TO: All Proposers
FROM: Jennifer Ryan
Deputy Finance Director
DATE: **July 16, 2021**
SUBJECT: **Addendum #04** – Bid# 22000048 – WPC Third Avenue Pumping Station
Improvements

Section 00 9113 Addendum No. 04

WPC Third Avenue Pumping Station Improvements
City of Flint, 1101 South Saginaw Street, Flint, Michigan 48502

ED-101

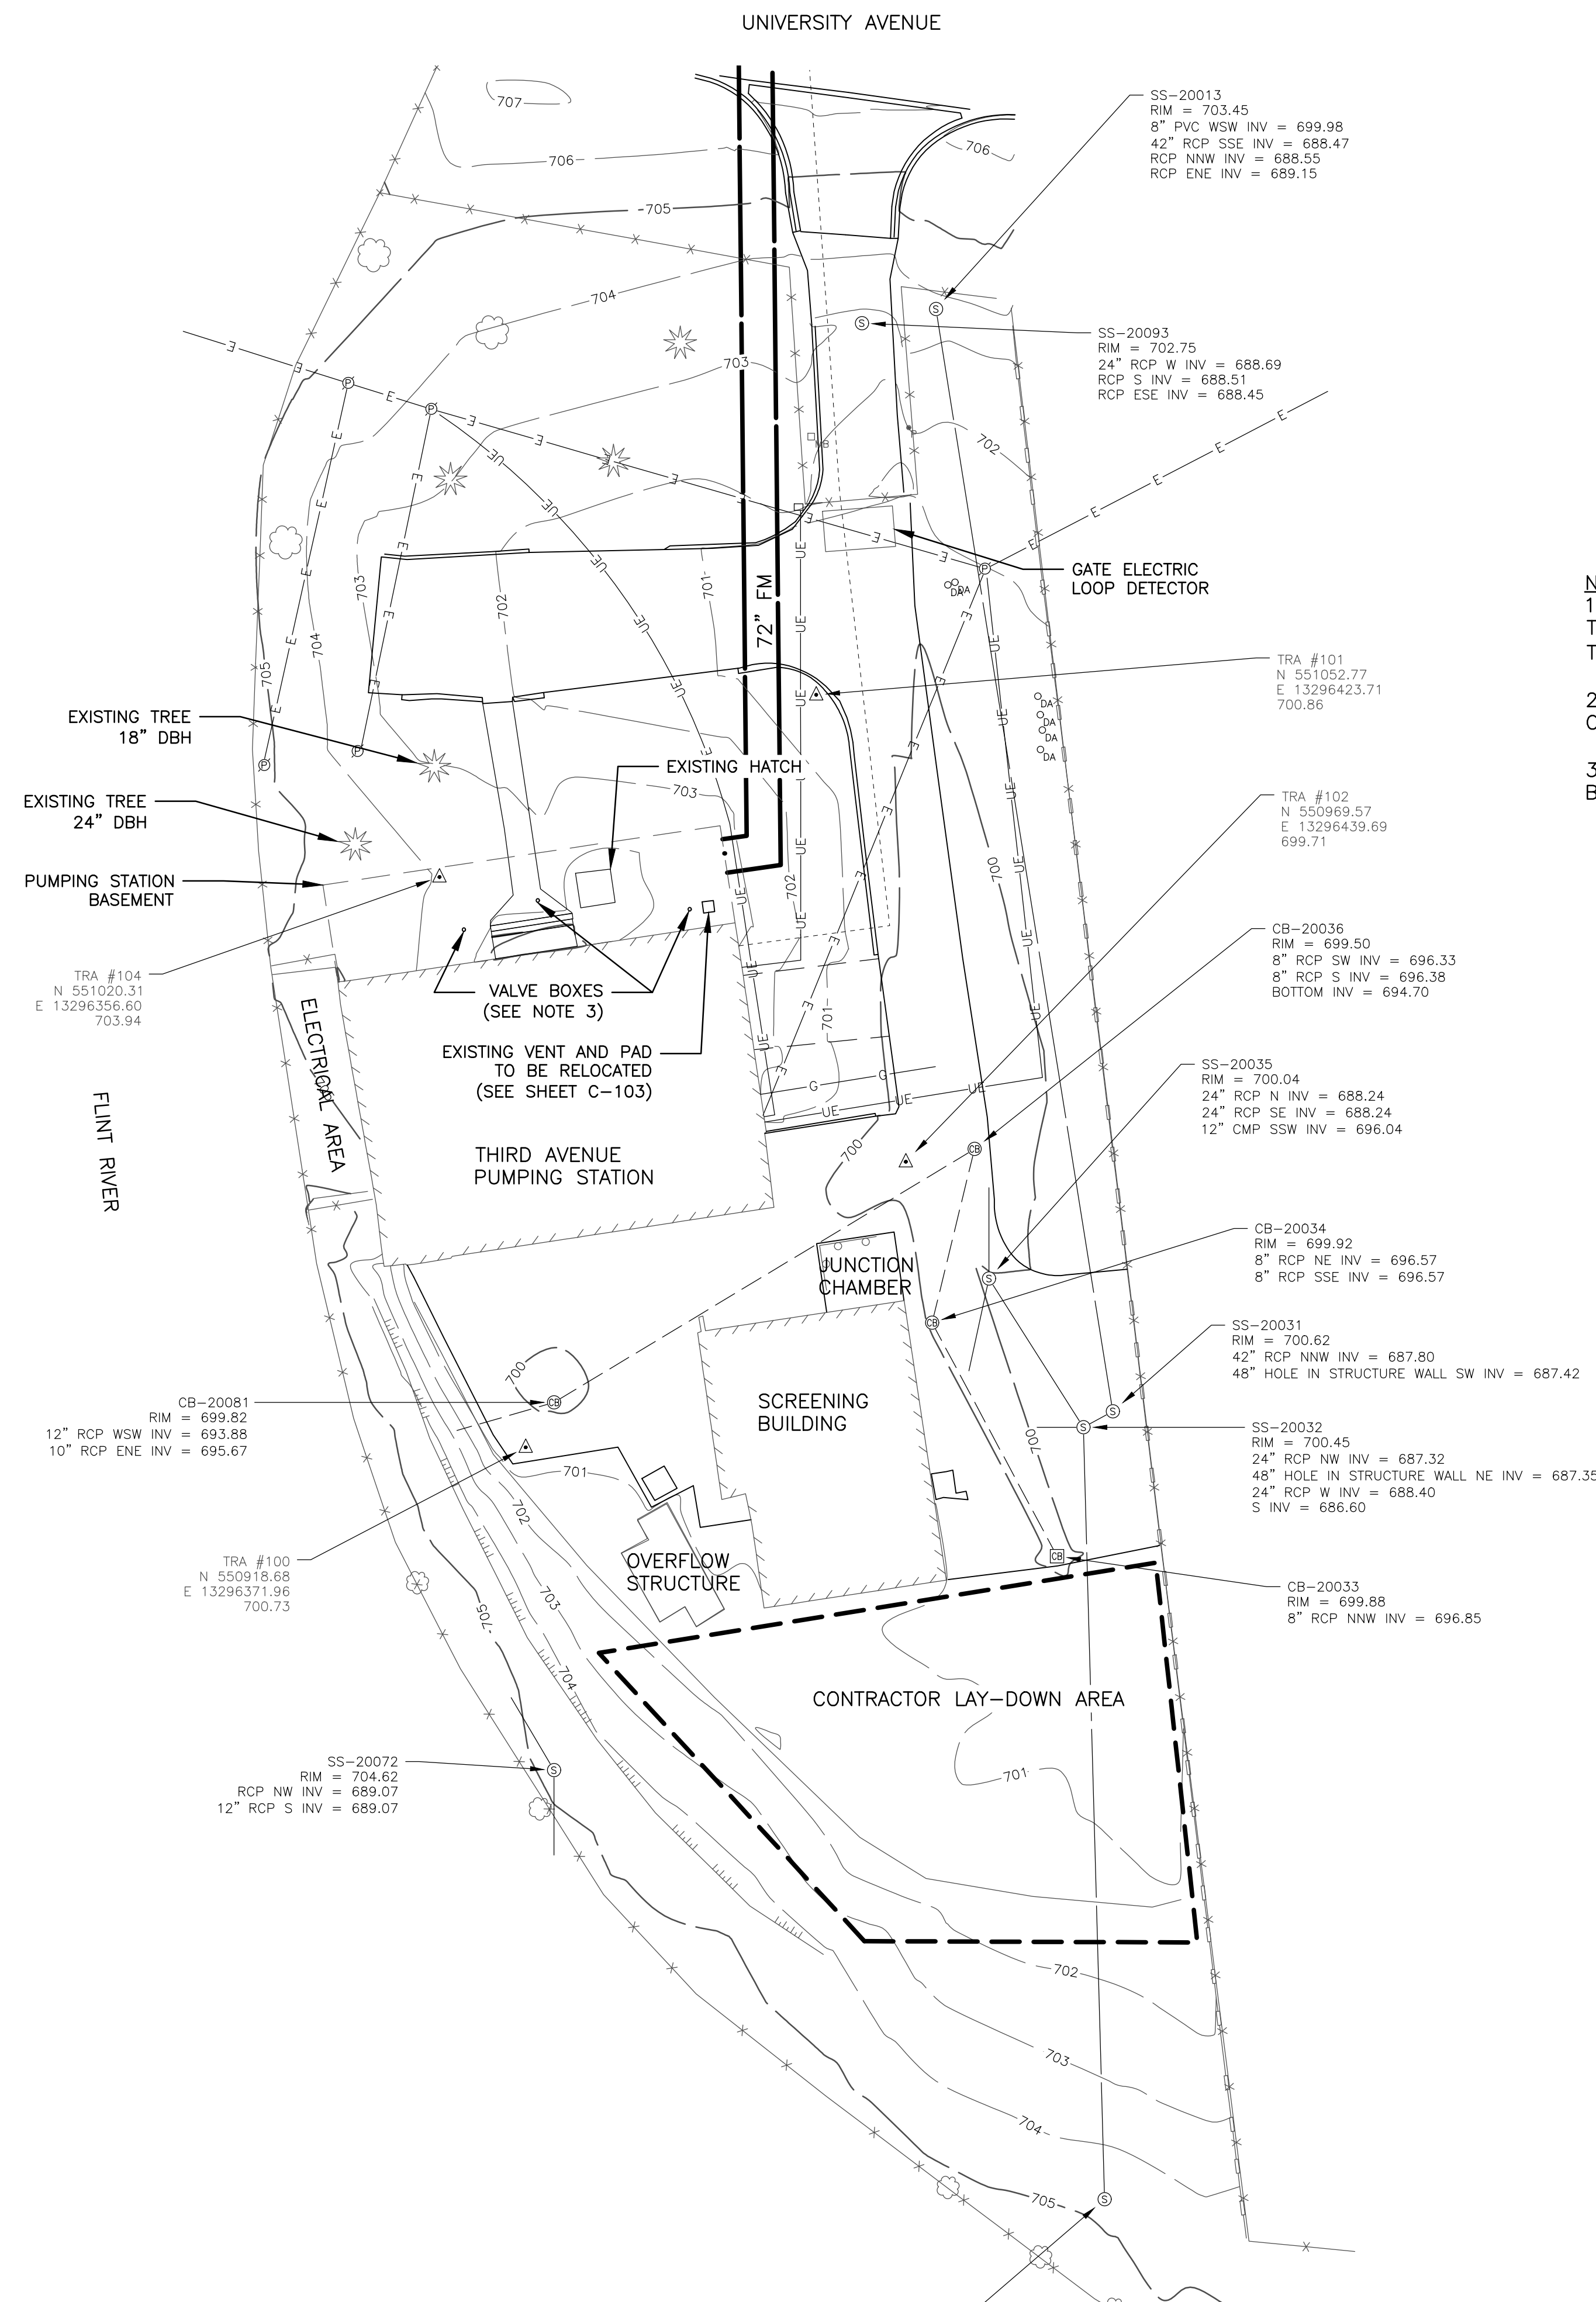
On Sheet ED-101, the following shall be added to the callout at P-3:

"... TO BE REMOVED (NOTE-13); MOTOR TO BE SALVAGED (SEE DD-301)"

On Sheet ED-101, the following Demolition Note shall be added:

"14. CONTRACTOR TO PROVIDE CRIBBING AS NECESSARY TO TRANSPORT THE SALVAGE MOTOR (FROM P-3) TO OWNER AT WPCF; CONTRACTOR TO OFFLOAD AND STORE MOTOR IN DESIGNATED LOCATION."

SHEET
C-101

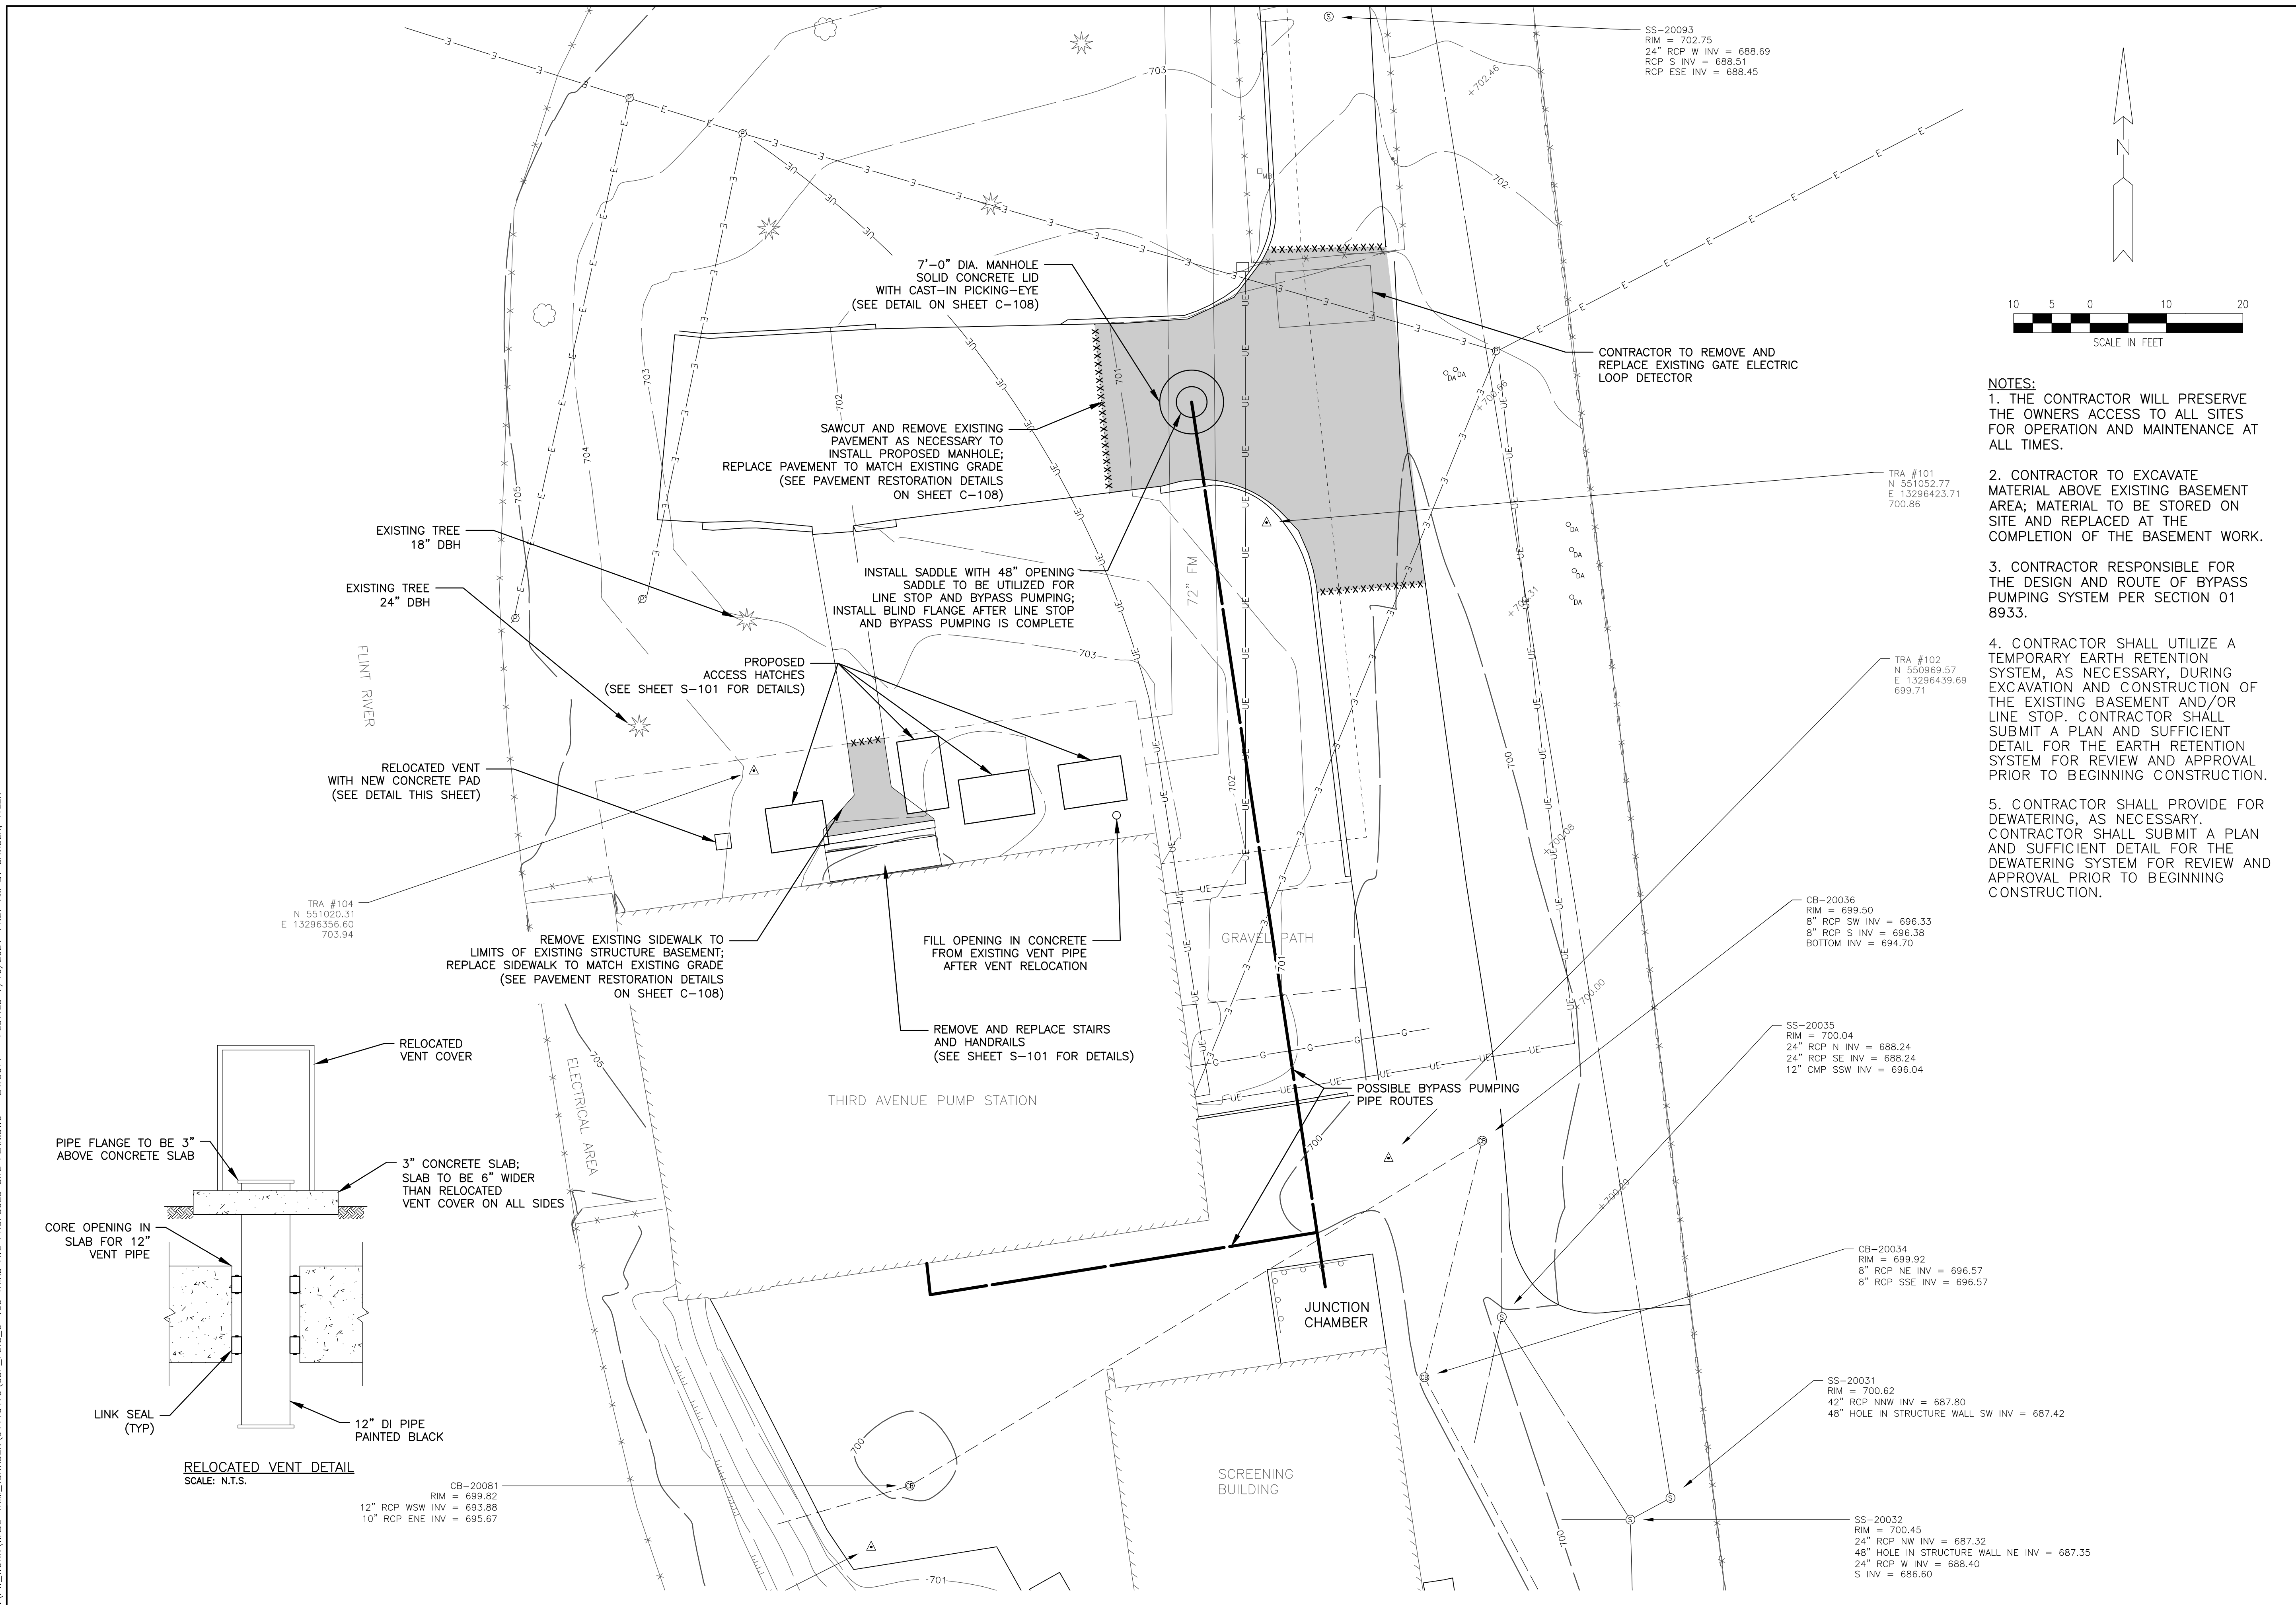
<u>Sheet</u>	<u>Description</u>
C-101	Sheet C-101 shall be deleted in its entirety and replaced with Sheet C-101 accompanying this Addendum.
C-102	The following is to be added to the end of Note 1 in the lower right hand corner of Sheet C-102: "VAULT LOCATION MAY NEED TO SHIFT DEPENDING ON FINDINGS. CONTRACTOR TO SUBMIT VAULT LOCATION LAYOUT BASED ON FINDINGS OF EXPLORATORY EXCAVATION FOR REVIEW AND APPROVAL."
C-103	Sheet C-103 shall be deleted in its entirety and replaced with Sheet C-103 accompanying this Addendum.
C-108	For the WPCF LINE STOP DETAIL shown in the lower right hand corner of Sheet C-108, the callout for the concrete to be placed around the saddle shall be revised to read as follows: "CONCRETE TO BE PLACED AROUND SADDLE AT A MINIMUM OF 2'-0" GREATER THAN SADDLE AND PIPE DIMENSION ON ALL SIDES; REINFORCING TO BE DESIGNED BY CONTRACTOR" The following general Note shall be added to Sheet SD-102:
